August 3, 2026 Water Quality Meeting Addendum: E-Mails sent & responses

From: Joan Rodriguez <jblue406@aol.com>
To: Alicia H. West <awest@dep.nyc.gov>; Victoria Sacks <sacks.victoria@epa.gov>
CC: WQ
Sent: Monday, July 6, 2026 at 07:47:17 PM EDT
Subject: What is the plan once the CSO tanks go live?

Gowanus Proposed Sewer Upgrades

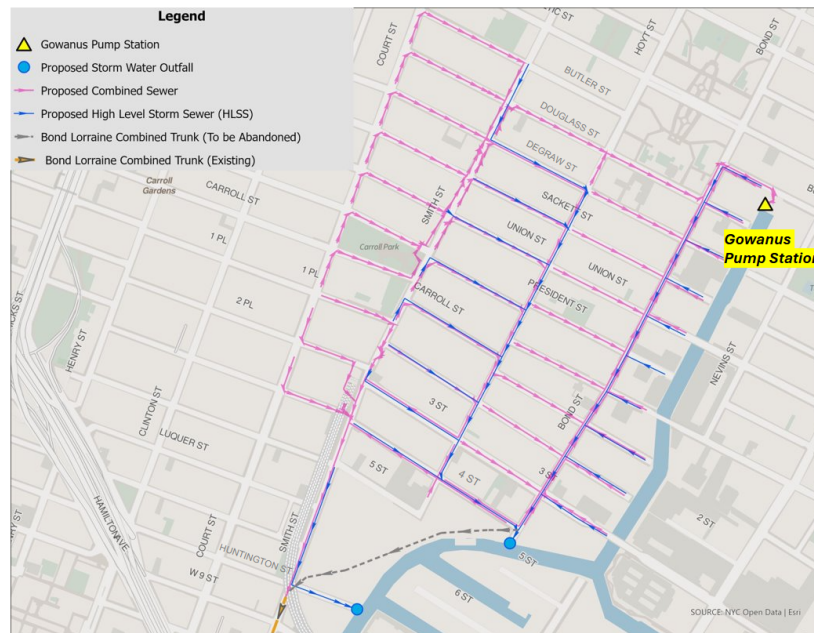
At two recent Gowanus community meetings the issue of the Bond-Lorraine Sewer came up. I was told at the Gowanus Oversight Task Force Meeting that there is currently NO funding for replacement of the Bond-Lorraine Sewer in the City's budget. The CAG Water Quality Committee seeks information regarding the City's plan to replace the Bond-Lorraine Sewer including, but not limited to:

From where will the funding for sealing & replacement of the Bond-Lorraine sewer be found?

If that is so, are developers sealing the old sewer AND building the new one? To what extent is this envisioned to be DEP contracted work as opposed to developer work?

construction of a new sewer assuming the old Bond-Lorraine sewer will be replaced (in the same place or elsewhere)?

If it will be replaced elsewhere, where exactly?

They state that they intend to eliminate the old brick Bond-Lorraine sewer, including the section under Public Place:

"As presented at the 6/9 town hall, DEP is planning to address sewer back-ups that happen when rainstorms overwhelm the sewers west of the canal. We are looking at installing new dedicated storm sewers that will drain rainwater off the street and free up capacity in the combined sewer during rainstorms. The combined sewer ("Bond-Lorraine") beneath the Gowanus Green development site will ultimately be sealed and abandoned in place.

DEP funds capital sewer work with utility funds, i.e. water bills. DEP will fund the project and DDC will complete the design and construction. We plan to turn the project over to DDC for full design by the end of the year. The developers are not responsible for this work. I'm including below a drawing that illustrates where the new dedicated storm sewers are planned as well as the realignment of the combined sewers."

- DEP is planning to address sewer backups that happen when rainstorms overwhelm the sewers.
- DEP is looking at installing **new dedicated storm sewers** that will:
 - ✓ Drain rainwater off the streets
 - ✓ Free up capacity in the combined sewer during rainstorms
- The combined sewer ("Bond -Lorraine") beneath the Gowanus Green development site will ultimately be sealed and abandoned in place.
